RE: Notice of Decision - Approval of Application for Surface Drain No. 5362

**NOTICE OF DECISION
ON APPLICATION TO DRAIN NO. 5362
Spiritwood Lake Drain**

TECHNICAL MEMORANDUM

SUBJECT: Application for Surface Drain Permit No. 5362

Figure 2. NDRAM 10-year water surface elevation for 29th Street SE, Stutsman County

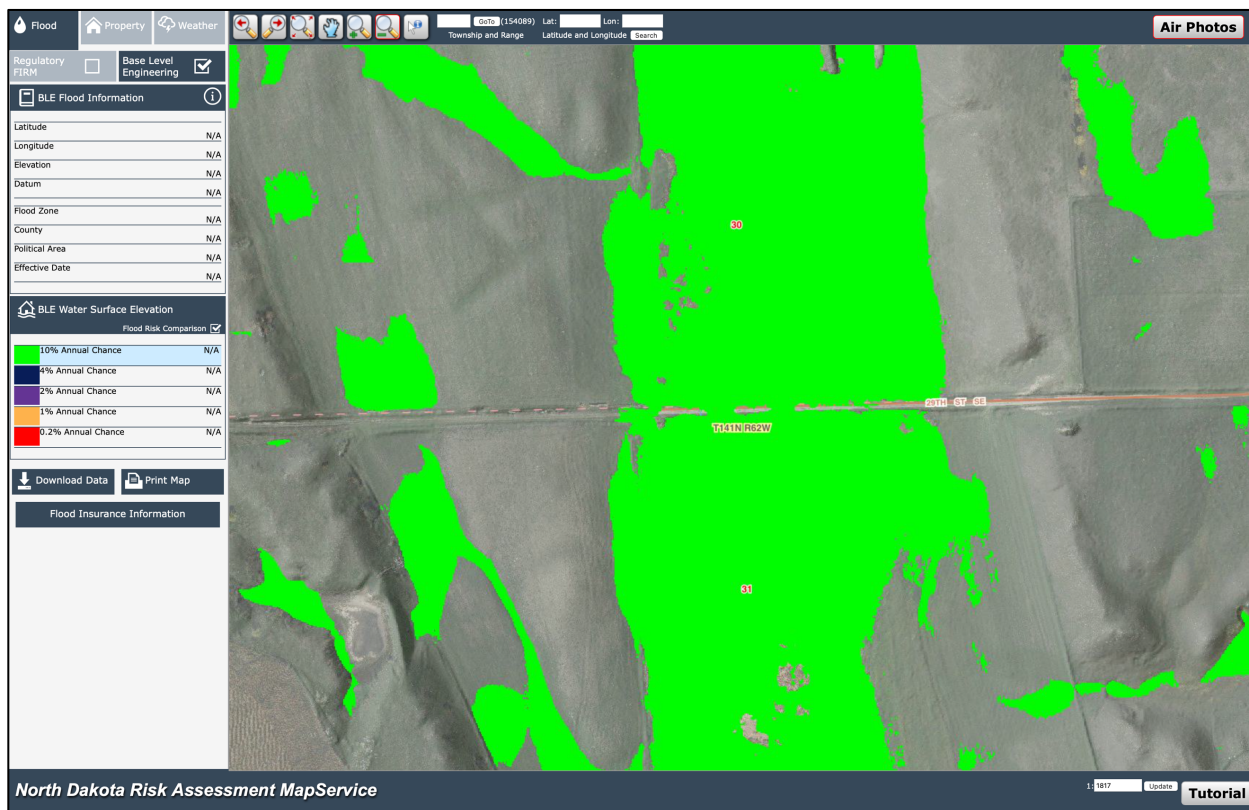
To provide context to these discharge results, other sources of data were referenced to determine a reasonable discharge from Alkali Lake without road overtopping. Firstly, North Dakota Risk Assessment Map Service (NDRAM), was referenced to determine if 29th Street SE overtops and for what return interval. According to NDRAM, 29th Street SE overtops by approximately 0.6 feet

during the 10-year recurrence interval (see **Figure 2**). Secondly, North Dakota Stream Crossing Standards and mapping resources were referenced. It appears 29th Street SE is a county, rural, off-system township road within Rose Township, Stutsman County, thus, requiring the passage of the 10-year recurrence interval discharge within allowable headwater requirements for compliance with Stream Crossing Standards (N.D.A.C. § 89-14-01-03. Design flood frequency). While it may not be fruitful to determine if the existing stream crossing meets Stream Crossing Standards, it is likely reasonable to assume that the Project should not add to or compound existing road overtopping for recurrence intervals when there is already road overtopping, such as the 10-year recurrence interval. Therefore, given that 29th Street SE overtops by only 0.6 feet for the 10-year recurrence interval and the 5-year recurrence interval discharge is almost half that of the 10-year, it could be reasonably assumed that 29th Street SE will not overtop during the 5-year recurrence interval discharge of 310 cfs.

This assumption was compared against a preliminary study for Spiritwood Lake being completed by the DWR's Investigations Section. The preliminary results from the existing conditions of that study agree with my findings that 27th Street SE, 29th Street SE, 30th Street SE, and 33rd Street SE township roadways, which are the more traveled township roadways downstream of the Project, do not overtop at their intersections of Sevenmile Coulee for the 5-year recurrence interval but do overtop for the 10-year recurrence interval. Given the study is still preliminary at the time of this writing, the results from the pending DWR study were not relied upon as best available data for my analysis of Sevenmile Coulee. Rather, the pending DWR study results were used to verify information obtained from USGS StreamStats and NDRAM data.

The Applicant stated in correspondence with the DWR that the Project will discharge approximately a maximum of 10 to 15 cfs from Spiritwood Lake. Assuming a worst case scenario of 15 cfs discharge from the Project when Alkali Lake is overflowing, 15 cfs would account for less than a 5-percent increase in discharge for Sevenmile Coulee for the 5-year recurrence interval.

Consequently, I do not envision the Project will have a noticeable effect or increase on water surface elevations in Alkali Lake or Sevenmile Coulee discharges. However, given the possibility that roadways crossing Sevenmile Coulee could overtop as frequently as the 10-year recurrence interval, I recommend a condition to an approved permit that will require halting operations of the Project if road overtopping within Sevenmile Coulee is observed.

17. The Permittee halt project operations when road overtopping on Sevenmile Coulee is observed downstream of the Project.
18. The Permittee must provide the final location and as-built details of the project to the District and the Department of Water Resources within six months after construction is complete.
